UNITED STATES PATENT AND TRADEMARK OFFICE

APPLICATION NO.	FILING DATE	FIRST NAMED INVENTOR	ATTORNEY DOCKET NO.	CONFIRMATION NO.
09/725,470	11/30/2000	Sang-Duk Lee	6192.0169.AA	1695

Office Action Summary

DETAILED ACTION

FIG. 4

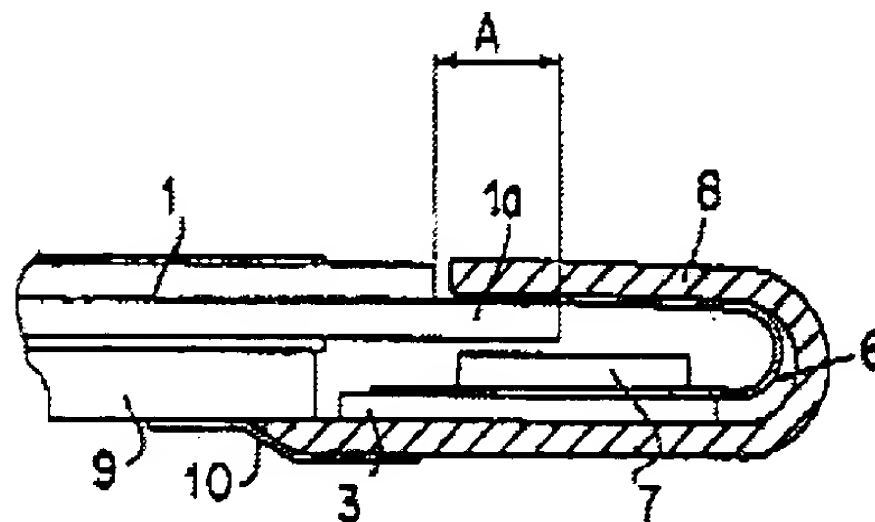
As to claim 1, Hashimoto discloses (summary of the invention, col. 2, line 31 through col. 3, line 26) an embodiment shown in Figure 4 (col. 5, line 18 through col. 7, line 52).

Figure 4 shows a liquid crystal display device comprising: a display unit having a liquid crystal display panel, 1, and a flexible printed circuit, 6, which is attached to the

liquid crystal display panel, for applying driving signals to said liquid crystal display panel for driving the liquid crystal panel; a light conductive plate, 9, (Applicant's back light assembly) which provides a light to the display unit; a glass plate to which everything is attached, 1a, (serves as Applicant's mold frame) for receiving the liquid crystal display panel and the back light assembly; a chassis, being coupled to said mold frame (not shown, see Figure 10), for fixing said liquid crystal display panel and said back light assembly to said mold frame; and a frame member, 8, that has a moderate level of resiliency for nipping the liquid crystal display panel, 1, and the circuit board, 3, (col. 5, lines 58-68) (Applicant's support means for supporting the flexible circuit board towards the mold frame).

FIG. 7

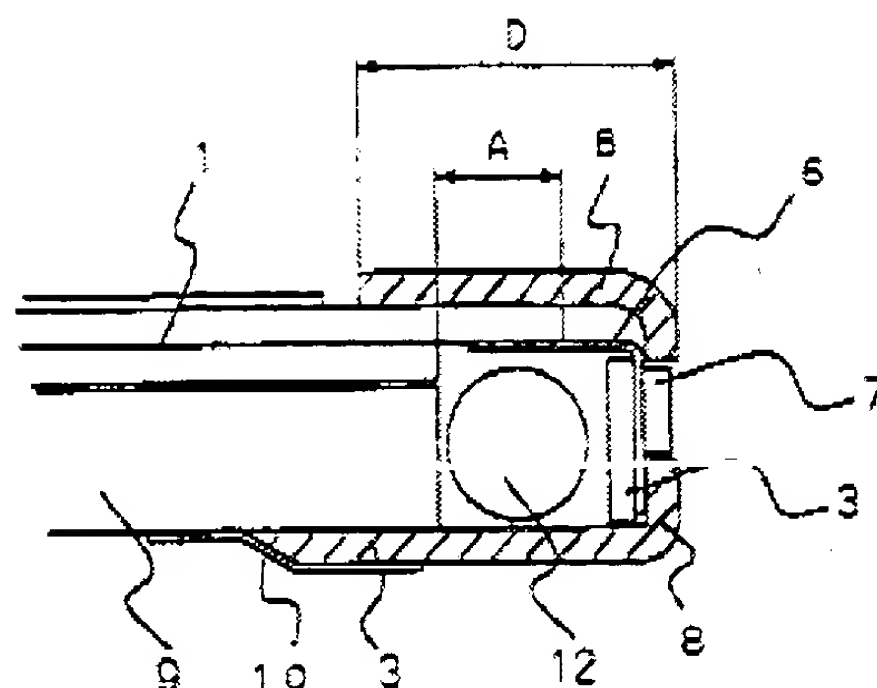
As to claim 2, Hashimoto discloses in Figure 7 a recess for receiving the integrated circuit, 7, in the frame member, 8, (col. 9, lines 3-7).

**FIG. 3**

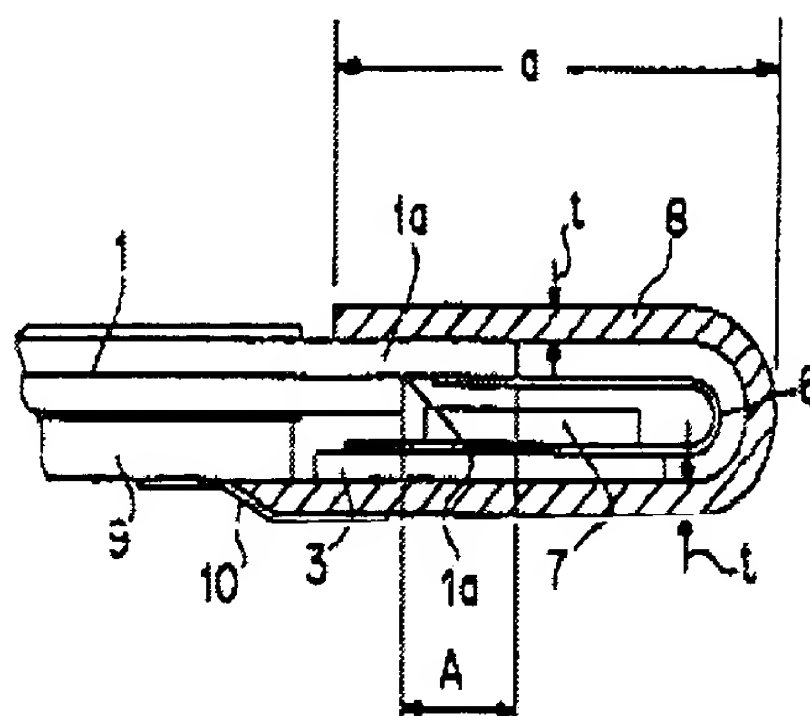
As to claims 2-4, Hashimoto discloses in Figure 3, a recessed portion between glass, 1a, and Integrated circuit, 7, (Applicant's portion of the receiving recess at the upper end of the outer side surface) of the device is deeper than a recessed portion between the liquid crystal display panel, 1, and the circuit board, 3, (Applicant's portion of the receiving recess at the lower end) thereof.
